MADISON WATER UTILITY

PLAN OF PROPOSED IMPROVEMENT

LAKEVIEW RESERVOIR PIPELINE IMPROVEMENTS PHASE 2

CITY PROJECT NO. 53W1903
MUNIS NO. 10439
CONTRACT NO. 7452

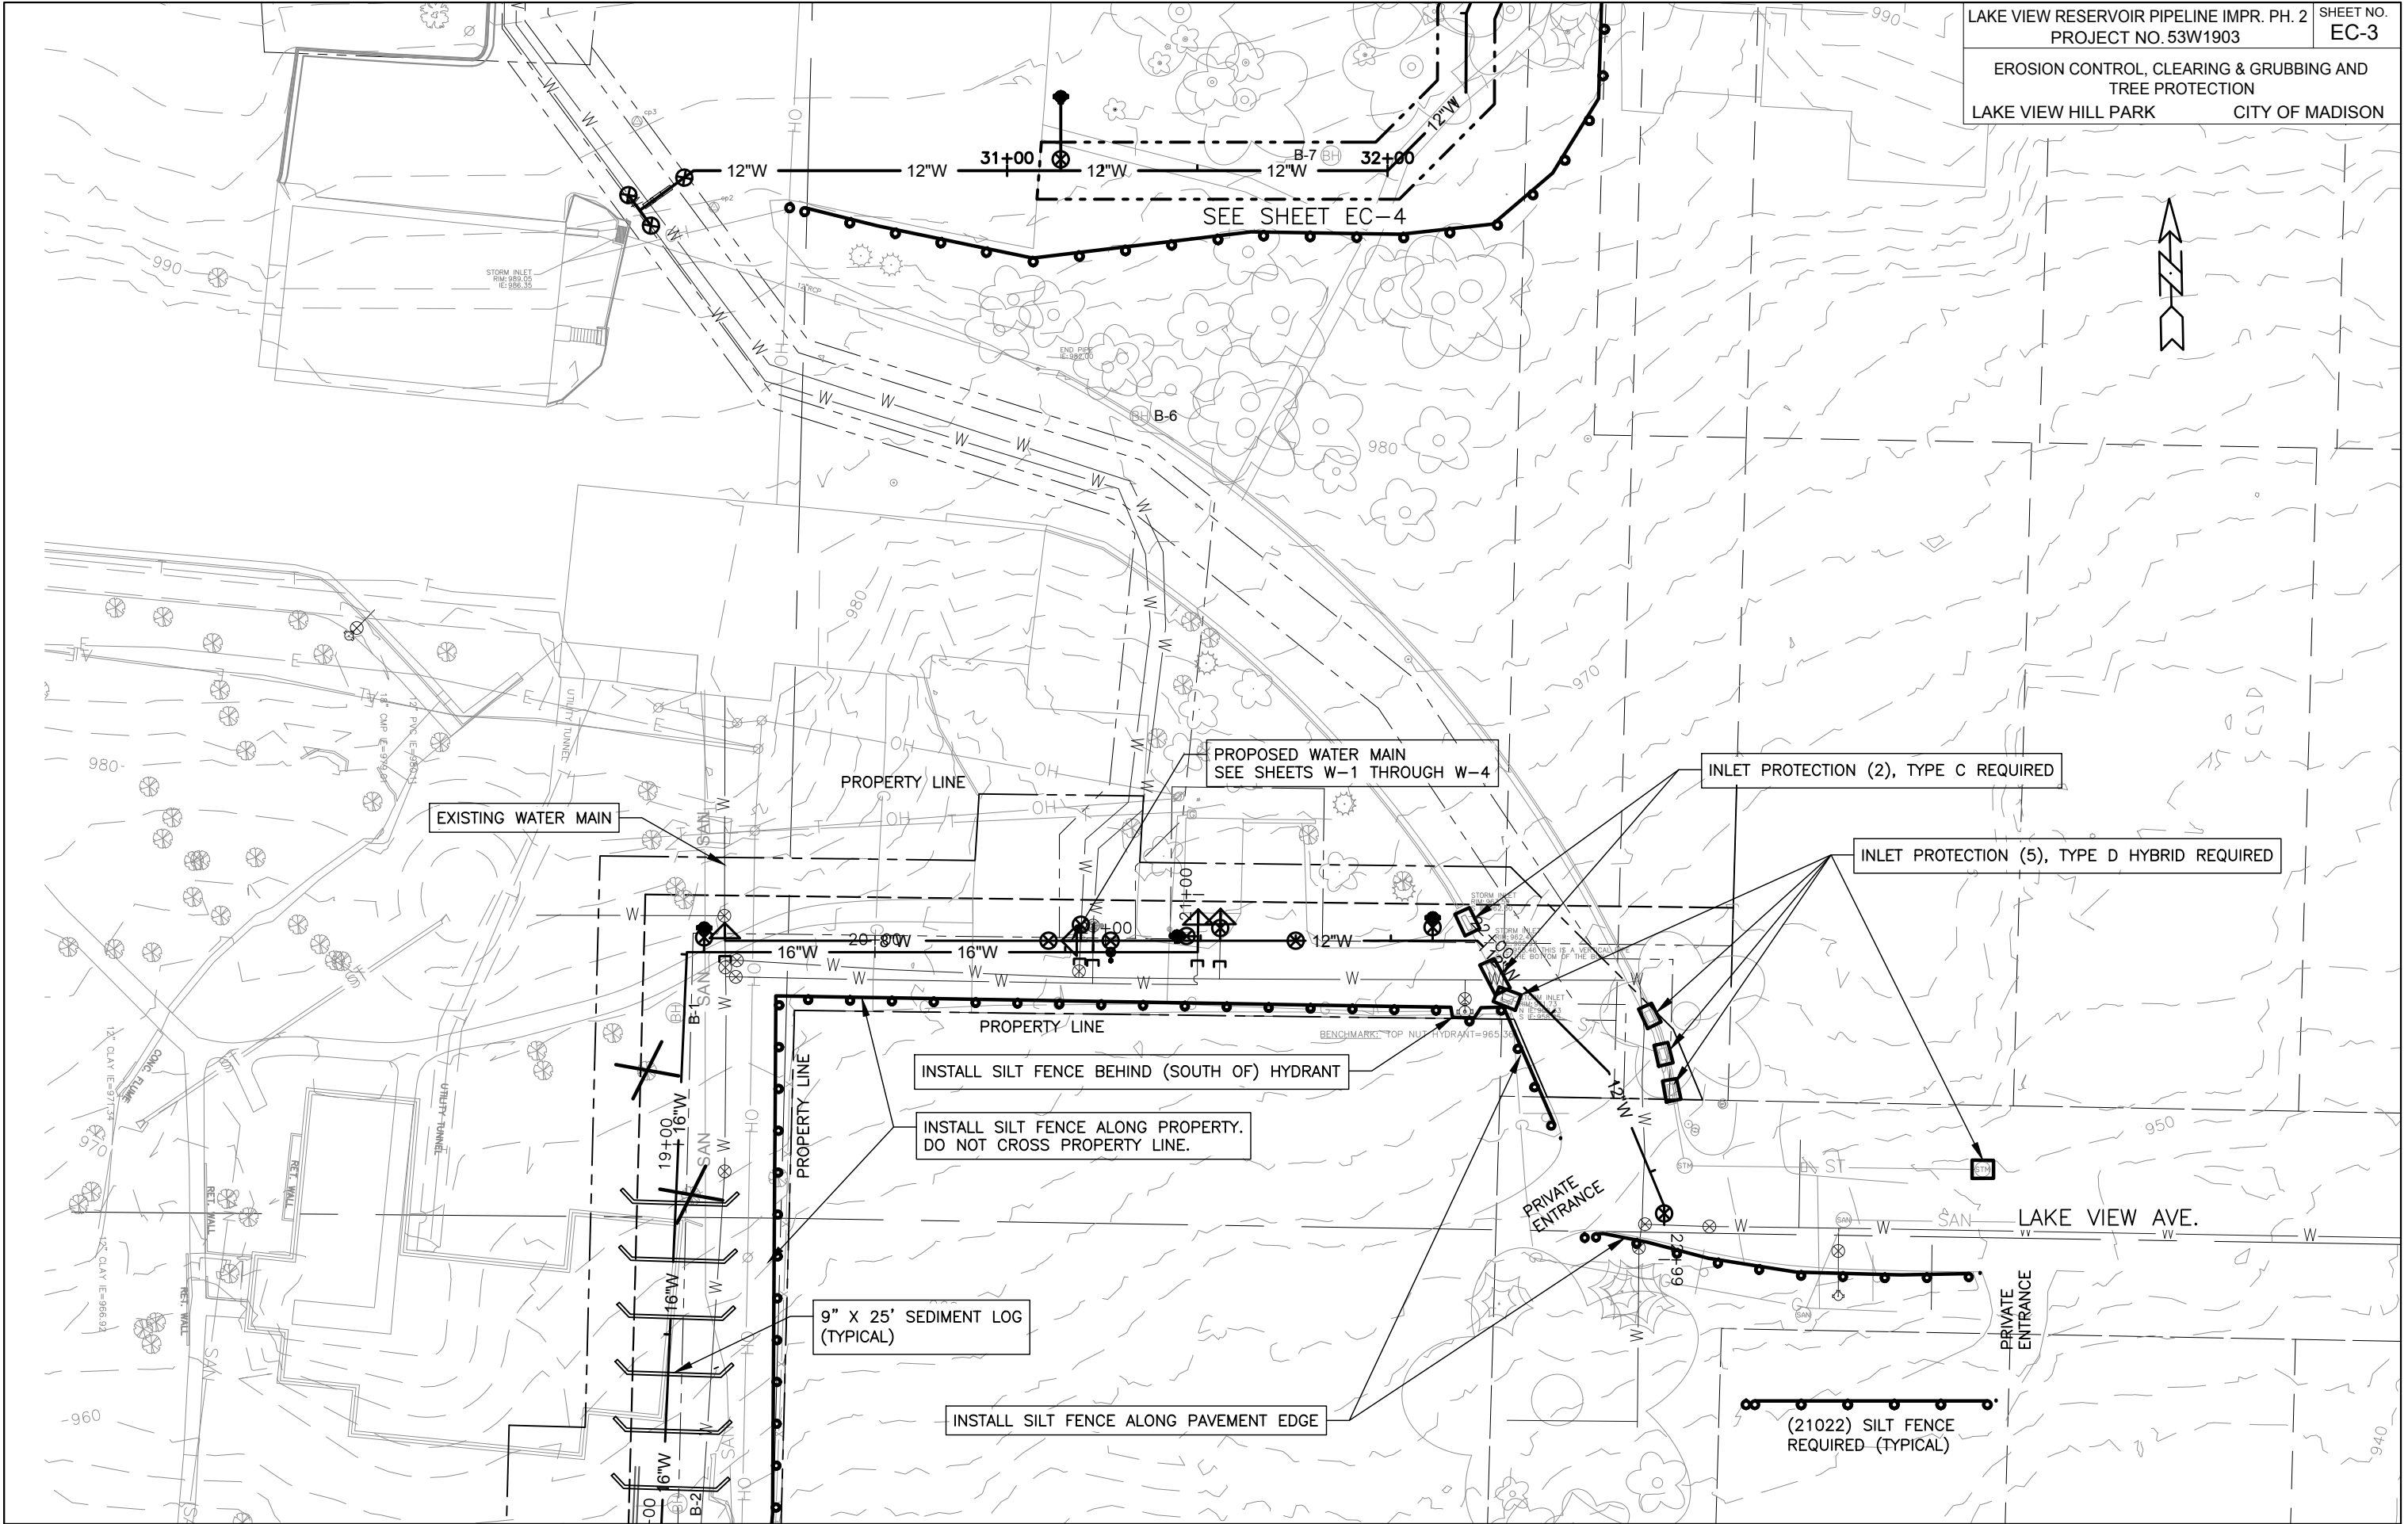
SUMMARY OF REVISIONS:
 -TREE AT STA ~19+20 CALLED OUT TO BE PROTECTED RATHER THAN REMOVED
 -RELECTS WATER MAIN REVISIONS ON SHEETS W-2 & W-3

DO NOT REMOVE TREES. TREE PROTECTION REQUIRED.
 PLACE CONSTRUCTION FENCE BARRIER AT 10 FT.
 MINIMUM FROM TREE TRUNK.
